Origination Form
Proposed Revisions to a Standard Plans Index

Originator:	Ryan Gray	Index Number:	110-200
Date:	4/16/2026	Sheet Number(s):	1 thru 3
E-mail:	Ryan.gray@dot.state.fl.us	Index Title:	Mailboxes

Summary of the changes:

LAST REVISION	REVISION	DESCRIPTION:		FY 2027-28 STANDARD PLANS	MAILBOXES	INDEX 110-200	SHEET 1 of 3
4/01/17	11/1/26

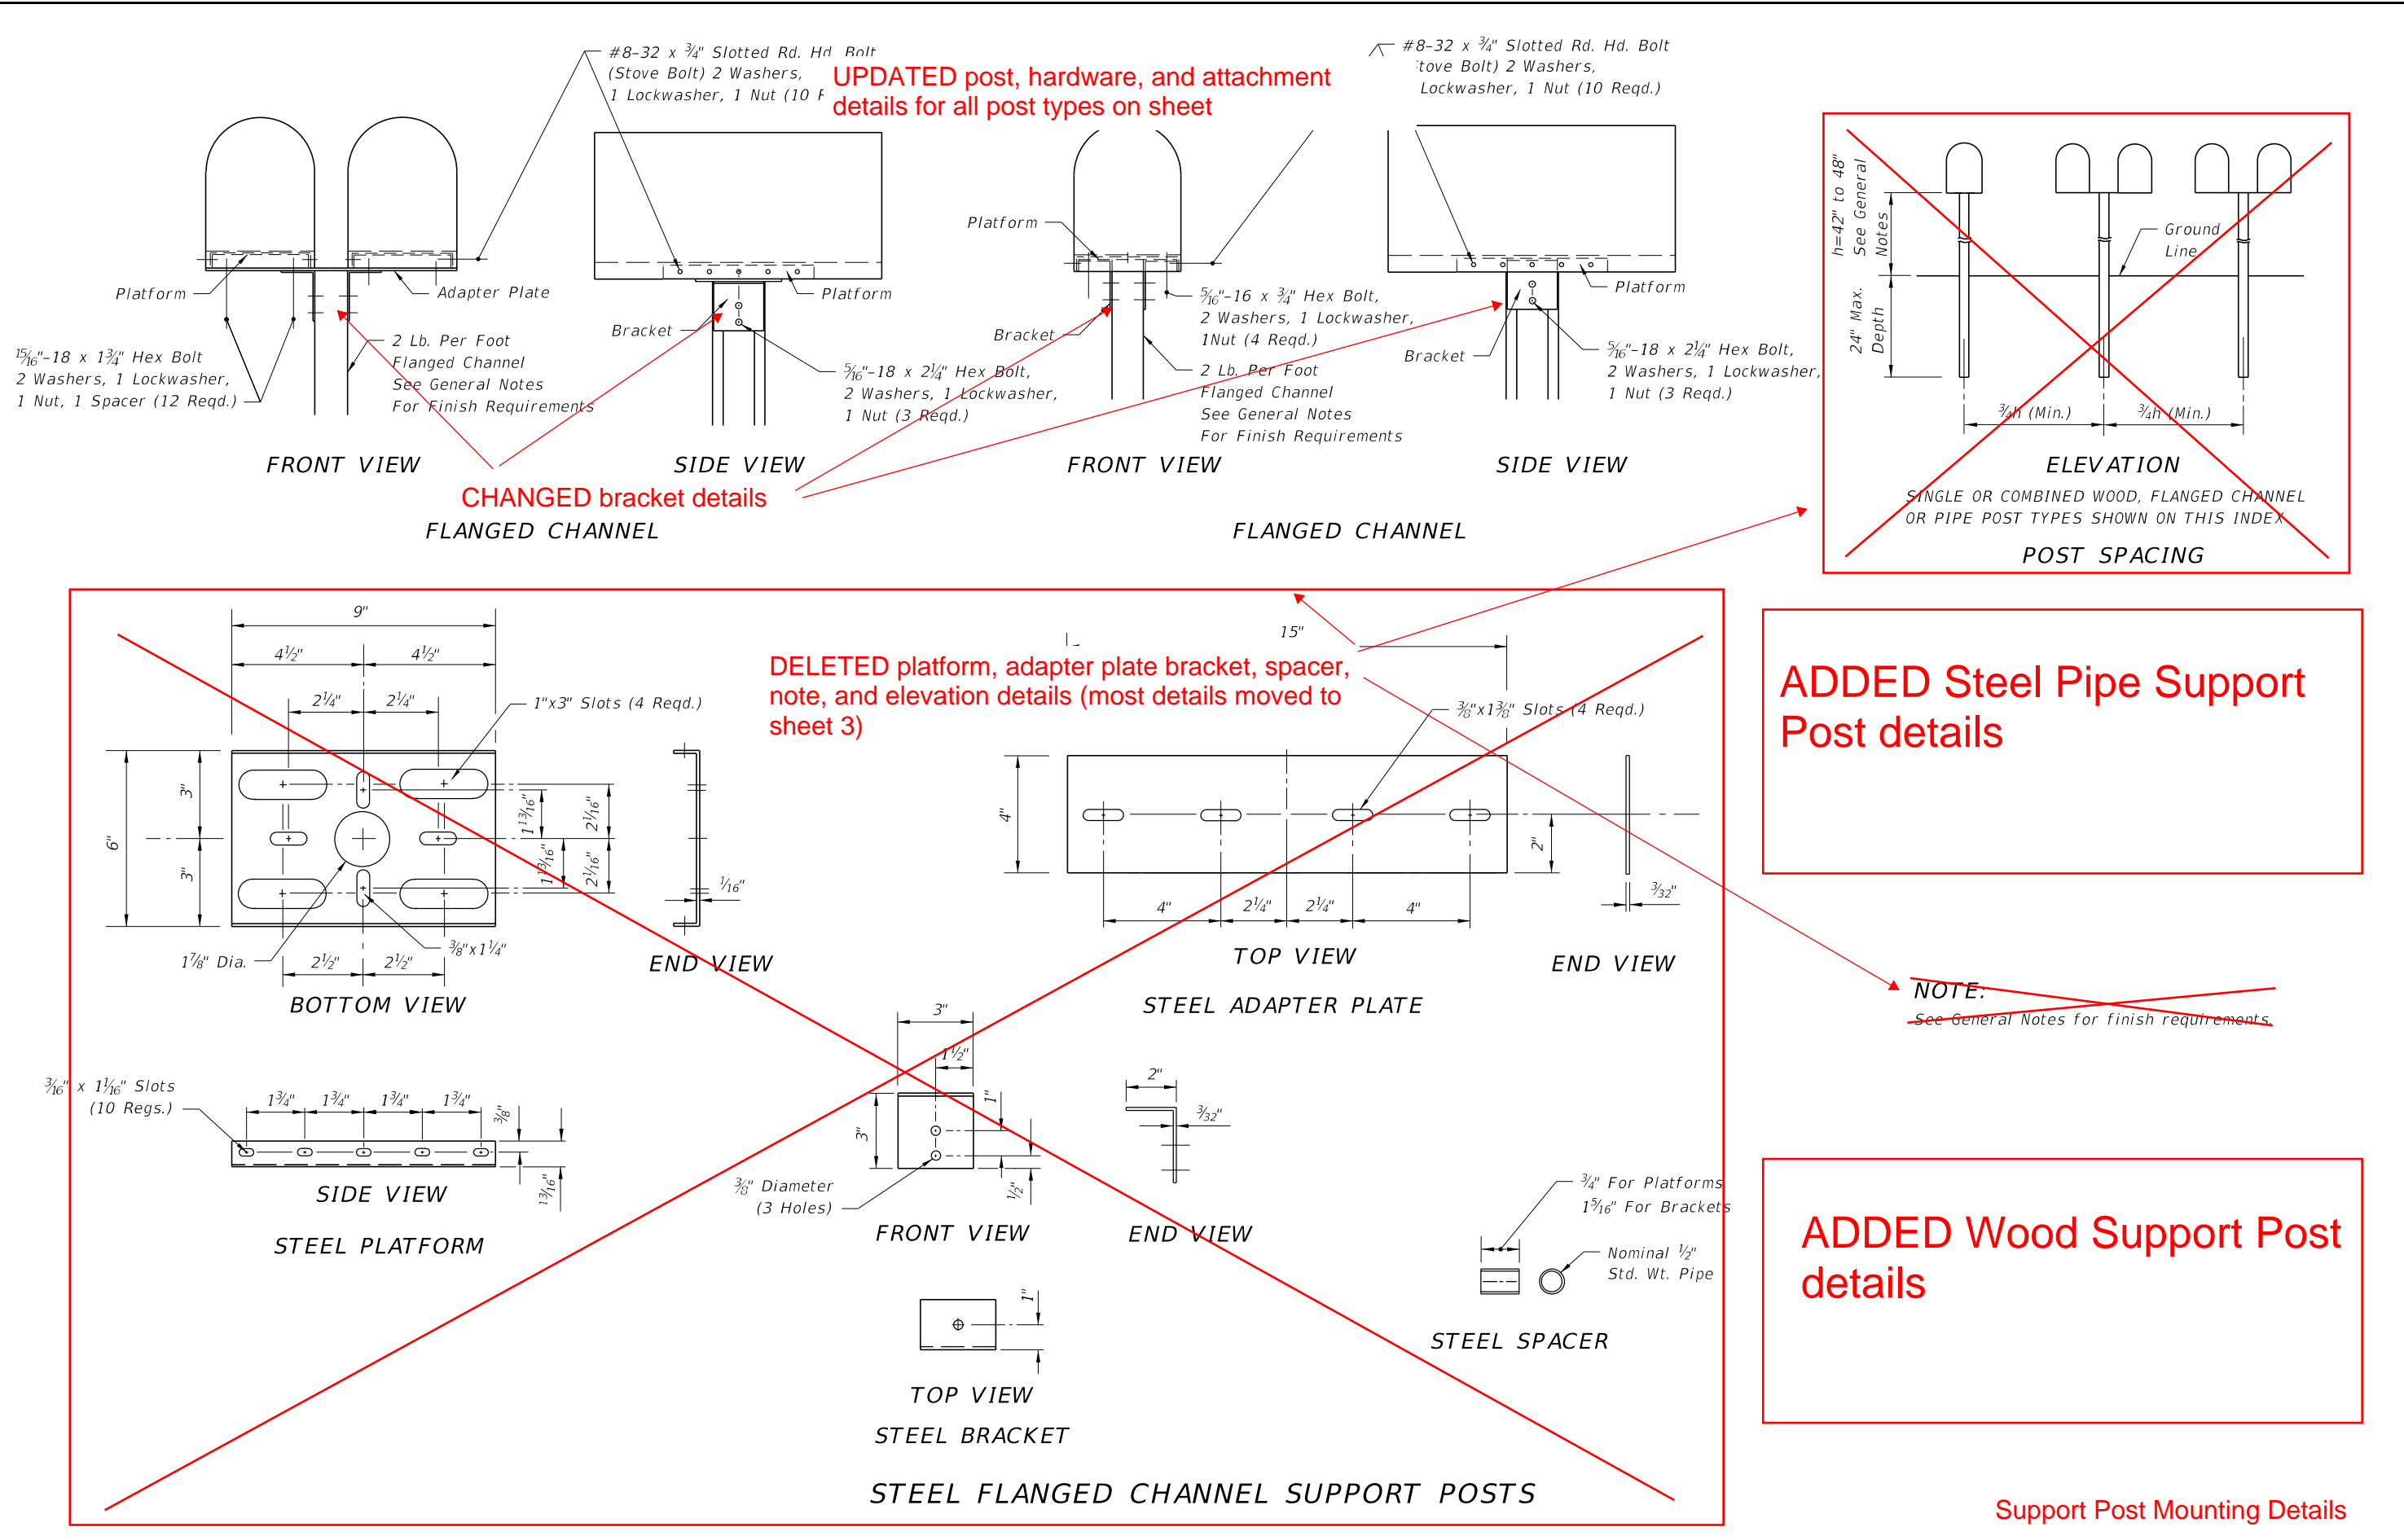
Sheet 1: CORRECTED General Notes regarding some measurements, external references, style. CHANGED contents of General Notes by moving some to Specs and/or SPI (Notes 3, 4, 11, and 12). ADDED isometric view of complete mailbox assembly;
 Sheet 2: CHANGED post mounting details for flanged channel. ADDED pipe and wood post mounting details and views. DELETED platform, adapter plate, bracket, spacer, and elevation details. UPDATED post, hardware, and attachment details;
 Sheet 3: UPDATED platform, shelf, bracket, elevation view, and anti-twist plate details. DELETED pipe post and wood post views. ADDED isometric views for platform, shelf, bracket, and plate. CORRECTED measurements in Elevation Detail.

Corrections are needed to align the Index with AASHTO and USPS requirements.

Moved to Standard Specifications or SPI

6. Mailboxes shall be set with the bottom of the box between ~~42" and 48"~~ 41" and 45" above the mail stop surface, unless the U.S. Postal Service establishes other height restrictions.

CORRECTED & CHANGED

ADDED Iso View of Mailbox Assembly

LAST REVISION	REVISION	DESCRIPTION:		FY 2027-28 STANDARD PLANS	MAILBOXES	INDEX 110-200	SHEET 2 of 3
4/01/17	11/1/26

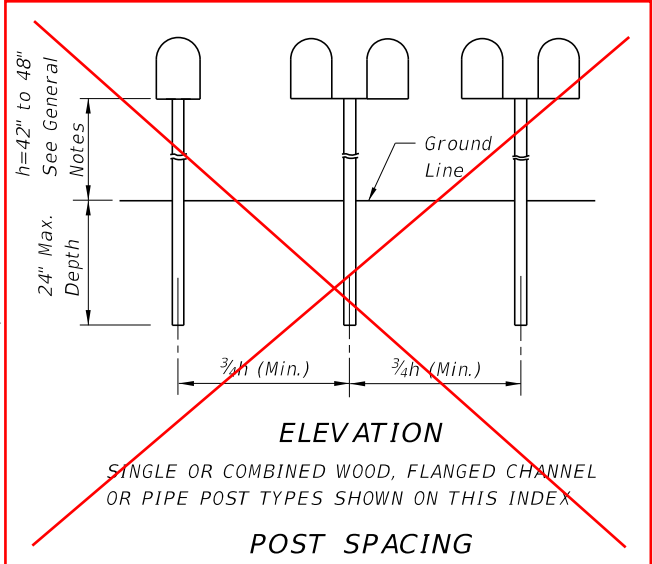
UPDATED post, hardware, and attachment details for all post types on sheet

CHANGED bracket details
FLANGED CHANNEL

ADDED Steel Pipe Support Post details

ADDED Wood Support Post details

DELETED platform, adapter plate bracket, spacer, note, and elevation details (most details moved to sheet 3)
